CAMPUS CORNER SUBDIVISION

APPLICATION NUMBER 7 DATE December 1, 2016

REQUEST Subdivision

DETAIL SITE PLAN

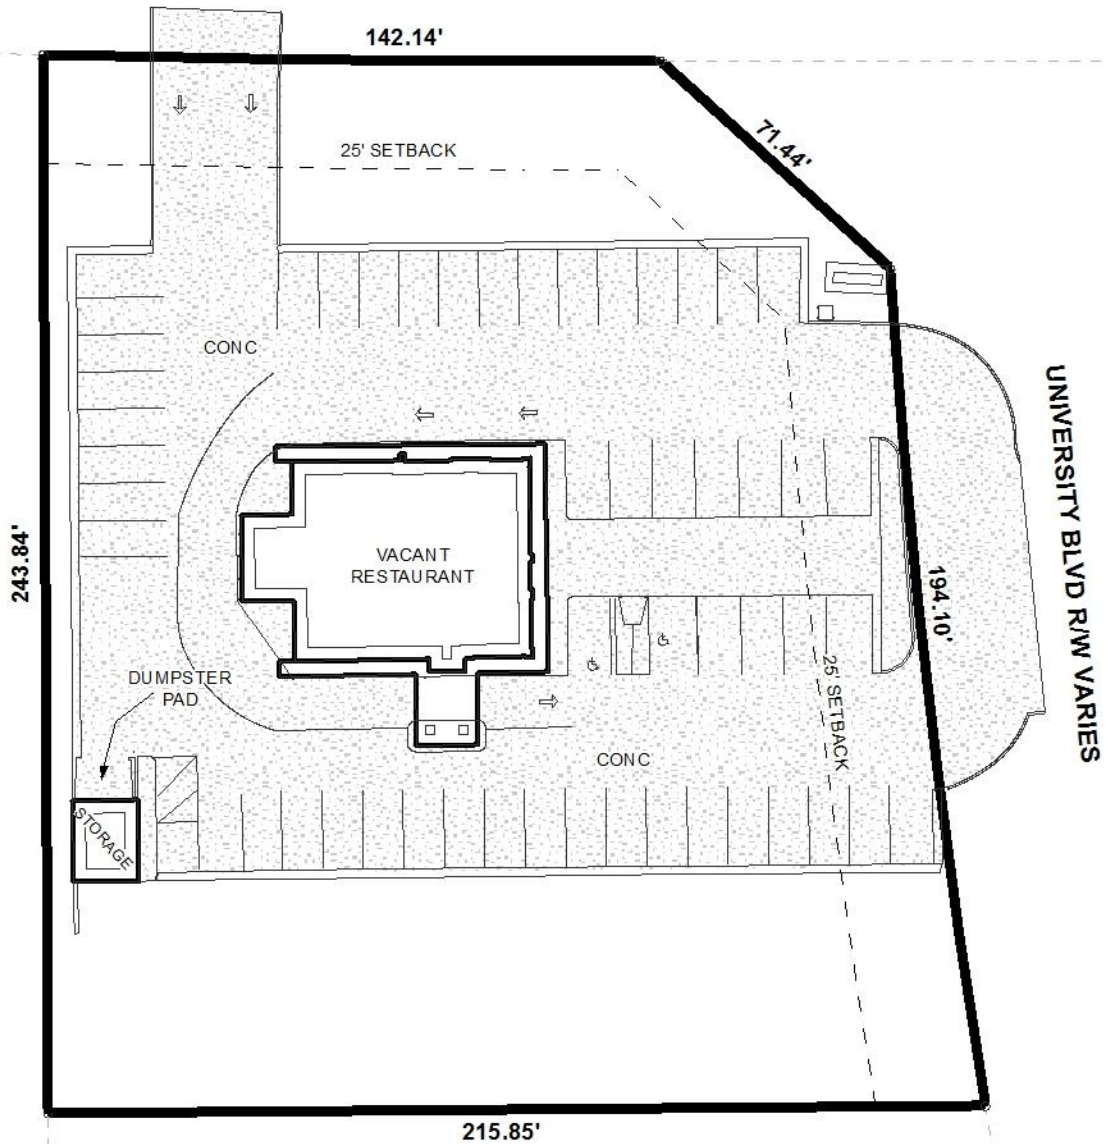
The site plan shows an existing curb cut to Old Shell Road, as well as two curb cuts to South University Boulevard. As a means of access management, a note should be required on the Final Plat, if approved, stating that the site is limited to one curb cut per street frontage, with the curb cut on South University be restricted to no left out, and with the size, location and design to be approved by Traffic Engineering and conform to AASHTO standards.

- 1) placement of the lot size in square feet and acres;
- 2) depiction of either the existing minimum rights-of-way for Old Shell Road and South University, or illustration that there is a minimum of 50' between the property line and the centerline along said streets;

- 3) dedication of compliant curb radius at the corner of Old Shell Road and South University Boulevard per Section V.D.6. of the Subdivision Regulations

- 4) placement of a note stating the site is limited to one curb cut per street frontage, with the curb cut on South University be restricted to no left out, and with the size, location and design to be approved by Traffic Engineering and conform to AASHTO standards;
